Planning Commission Staff Report

Project Type: Site Development Section Plan

Meeting Date: November 13, 2019

Description: **Mark Andy Industrial Park, Lots A and B (64 Corporate Center) SDSP:** A Site Development Section Plan, Landscape Plan, Lighting Plan, Architectural Elevations and Architect's Statement of Design for a 10.2-acre tract of land zoned "PI"—*Planned Industrial District* located north of Chesterfield Airport Road and northeast of its intersection with Spirit 40 Park Drive and northwest of its intersection with North Goddard Avenue, along Interstate 64. (17V510270).

1 NORTH ELEVATION - WEST SIDE
A201 1/16" = 1'-0"

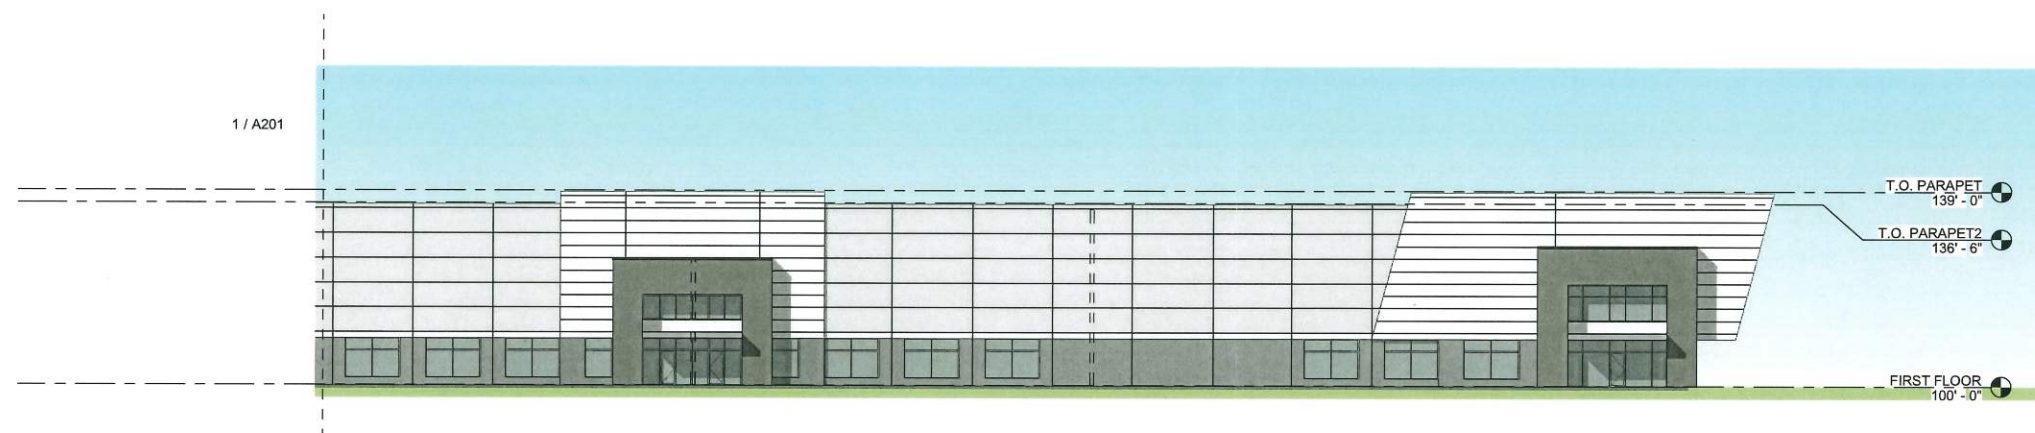
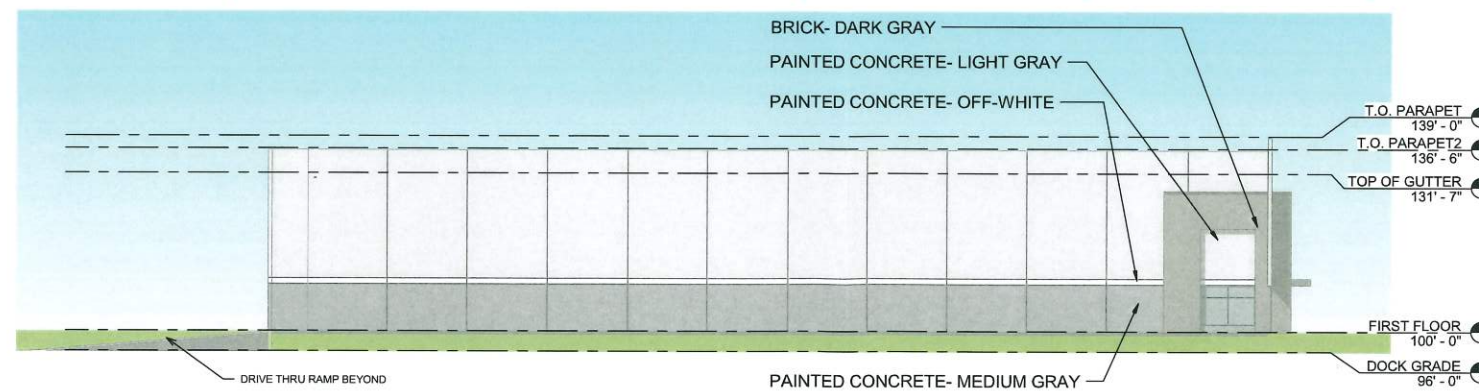
3. At the northeast and northwest corners of the building, where the windows return, the Petitioner is to work with revealing and paint color and changes of that to hold some of the articulates of the building, and reduce the amount of the dark mass of color on the side of the building, and to work with Staff to come up with a solution that helps break up that façade.

Response: The applicant has sufficiently fulfilled this request, as noted on the elevations.

DATE: 5/10/2019
JOB NO: 219-6507
SCALE: P. # 17'-0"
SHEET: 17-1
M.D.N.R. # MOR1A13714
SHEET TITLE: SITE DEVELOPMENT PLAN
SHEET NO.: C1.0

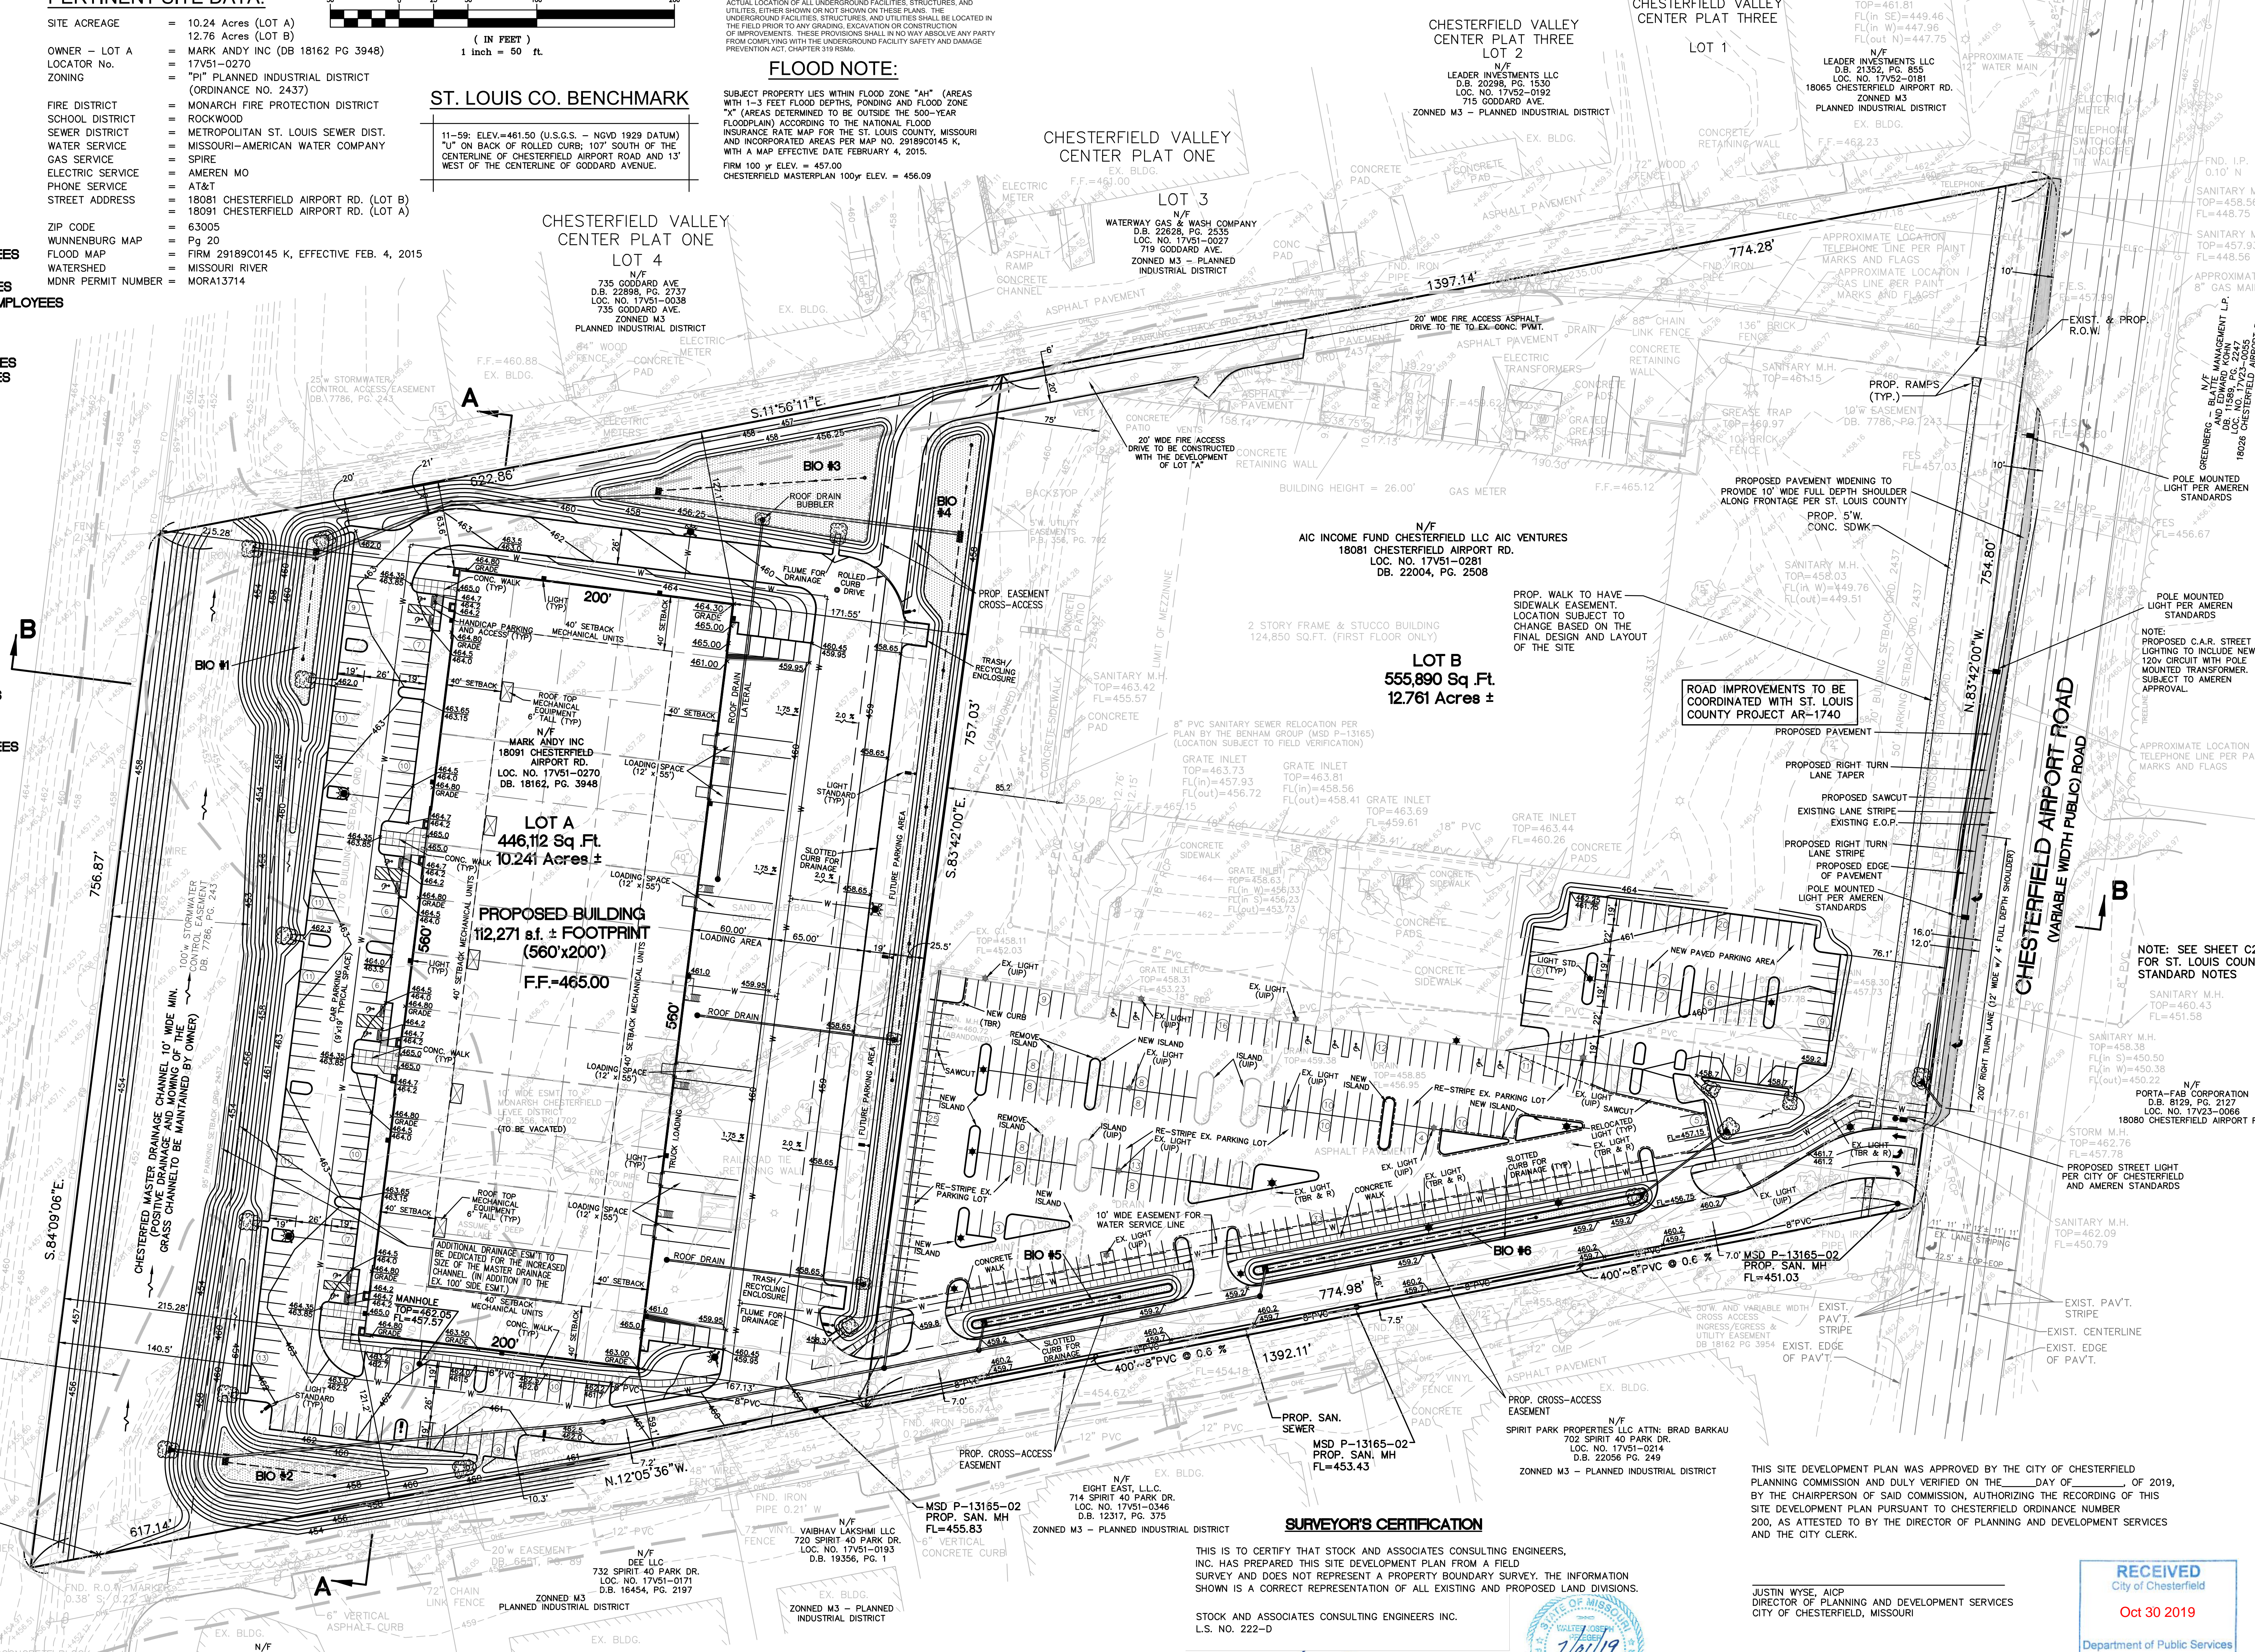
1. Define the setback from each edge of the building to the rooftop units based on the sight studies that were presented by the Petitioner.

Response: The applicant has provided these setbacks on the Site Development Section Plan.

PLANTING PLAN FOR THE PROPOSED
64 Corporate Center
CHESTERFIELD, MISSOURI

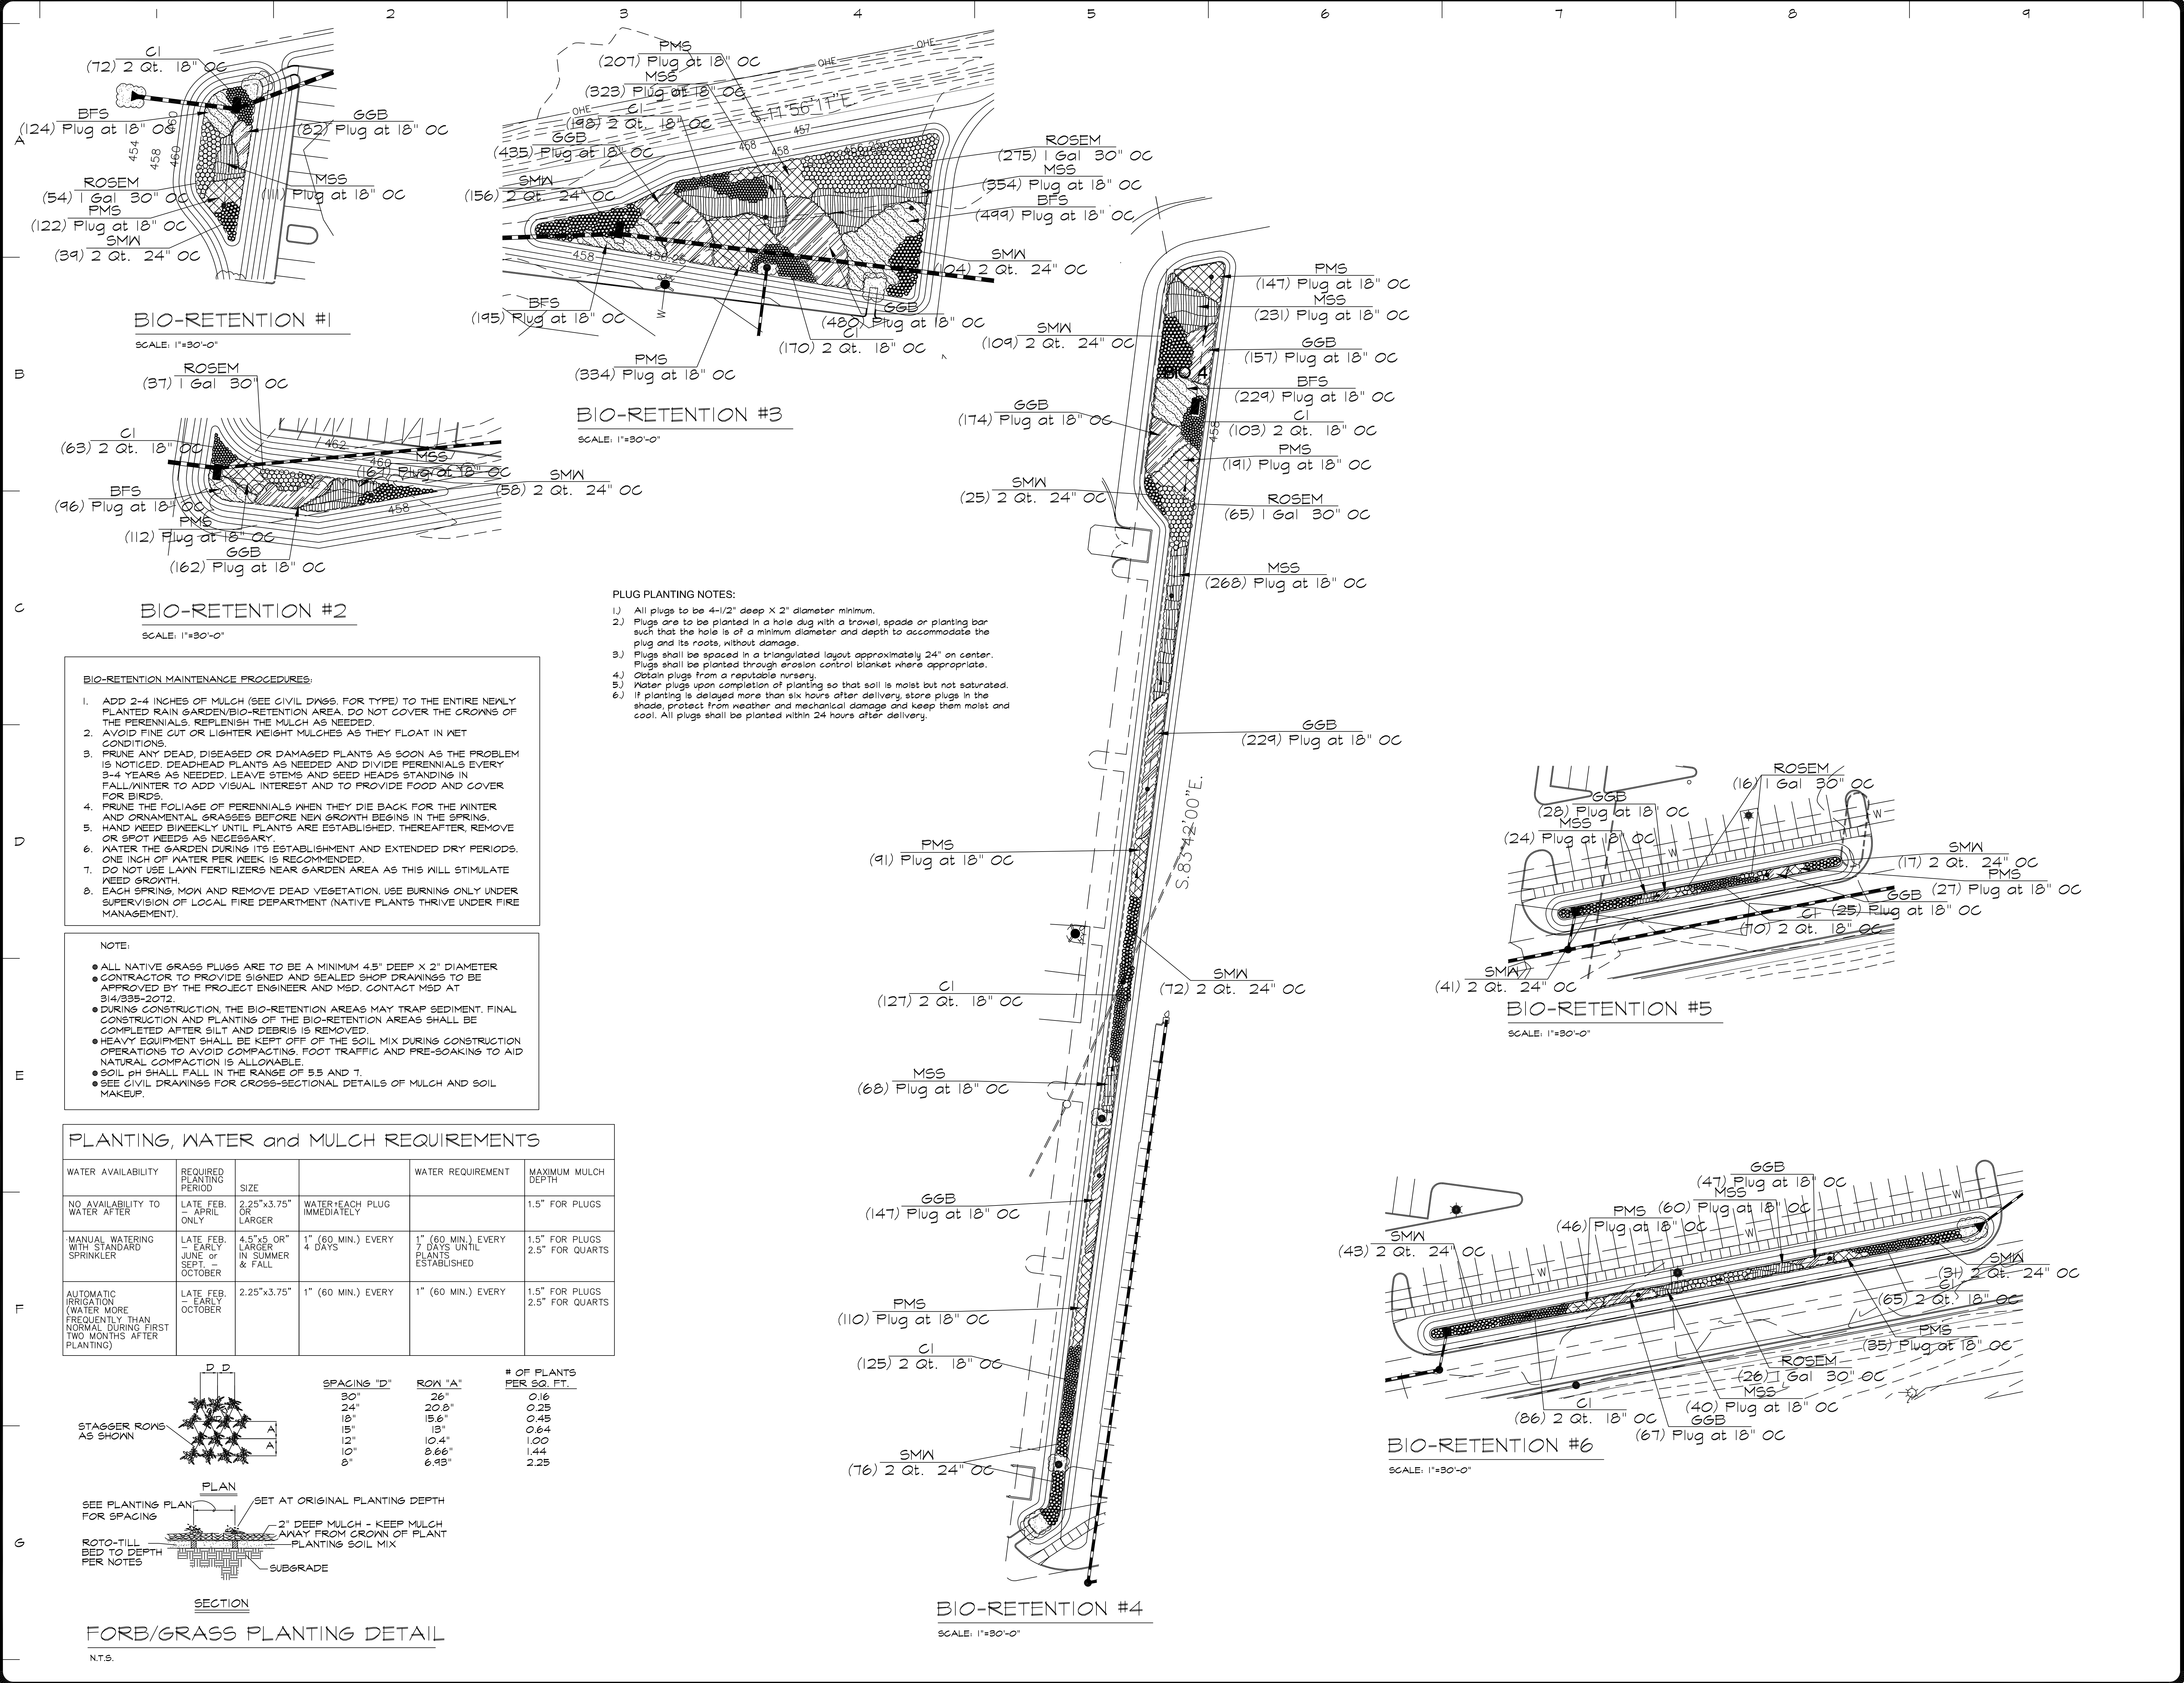
2. Look at the south side of the building, especially in the area of the parking lot adjacent to the loading docks of the proposed building, and increase the evergreen plantings for screening between the two lots to soften the view from Lot B.

Response: The applicant has sufficiently fulfilled this request by adding several evergreen plantings between buildings, as noted on the Landscape Plan.
